**HISTORIC LANDMARK COMMISSION  
MAY 21, 2012  
NATIONAL REGISTER HISTORIC DISTRICT  
NRD-2012-0046  
Willow-Spence  
1002 Willow Street**

Construct a new approximately 1,500 sq. ft., detached, two-story, 3 car garage with office.

SCALE:  $\frac{1}{4}'' = 1'-0''$

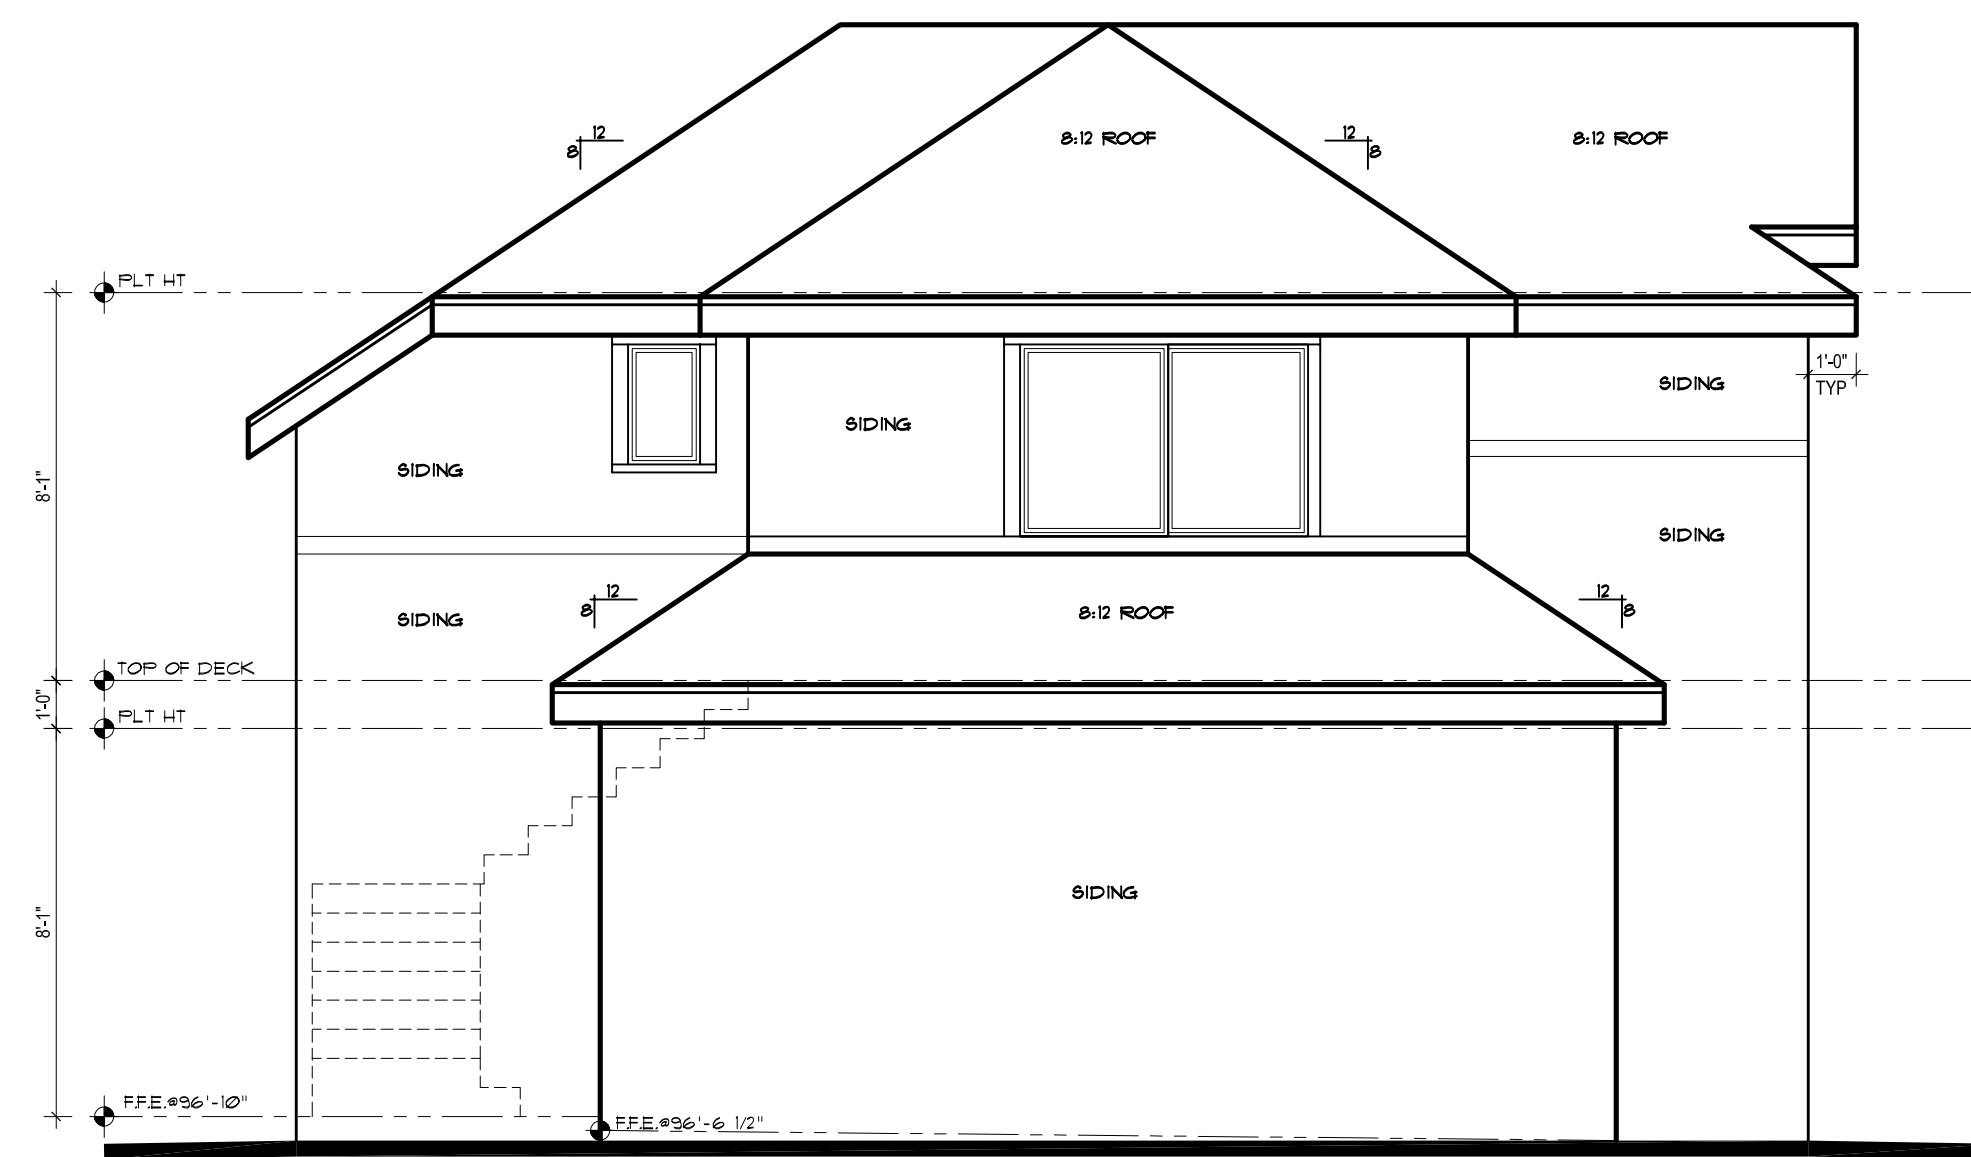
The garage will have a multiple-pitch, hipped roof, with narrow eaves. Wall and roof materials will be 4-5" wide, horizontal Hardiplank siding, and asphalt shingles to match the existing house. The garage doors will be panelized metal.

The proposed new structure is to the rear of the property and its scale and materials are compatible with the National Register District.

Release the permit per the proposed design.
